**DEFENSE NUCLEAR FACILITIES
SAFETY BOARD**

Staff Report

Observations Related to the Inadvertent Tritium Release Event

Figure 1. *H-Area New Manufacturing (HANM) and nearby buildings.*

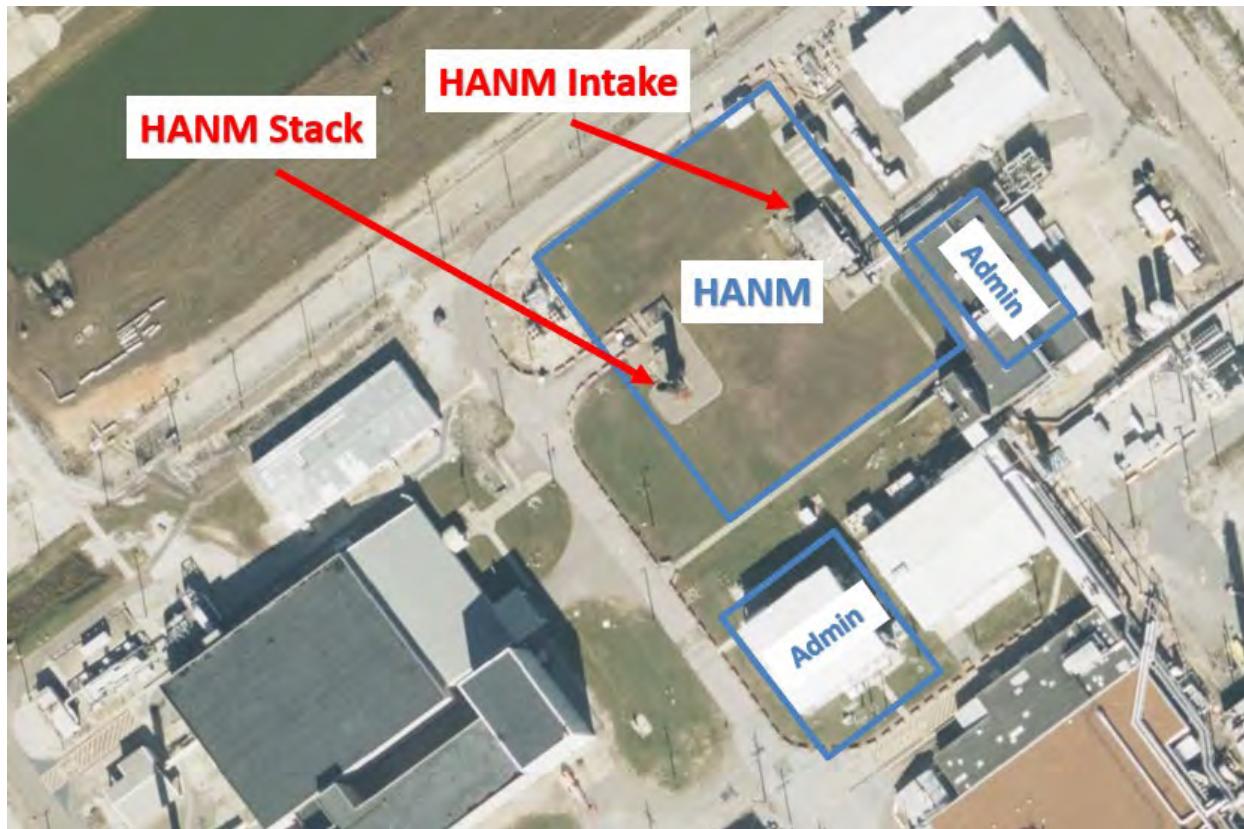
Following the event, SRNS determined that approximately 1000 curies of tritium gas from the recovered gas dryer was released from the HANM stack. The HANM ventilation supply intake, which is approximately 150 feet from the 50-foot-tall exhaust stack, pulled some of the tritium back into the facility (see Figure 1). The tritium then spread through occupied portions of the facility where tritium would not normally be found, including the corridors and control room.

Facility Design—The event at HANM demonstrated that radiological material released from a facility could get pulled back into the facility by its ventilation system. While this phenomenon is most challenging for tritium gas or vapors, which are not effectively filtered at the building’s exhaust or inlets, it is a consideration for any radionuclide. This phenomenon is not a new or unique concern. The Board raised this issue 27 years ago in DNFSB/TECH-3, *Overview of Ventilation Systems at Selected DOE Plutonium Processing and Handling Facilities* [3]. The Board also recently raised this topic in its review of the Savannah River Plutonium Processing Facility (see letter dated January 24, 2022) [4].
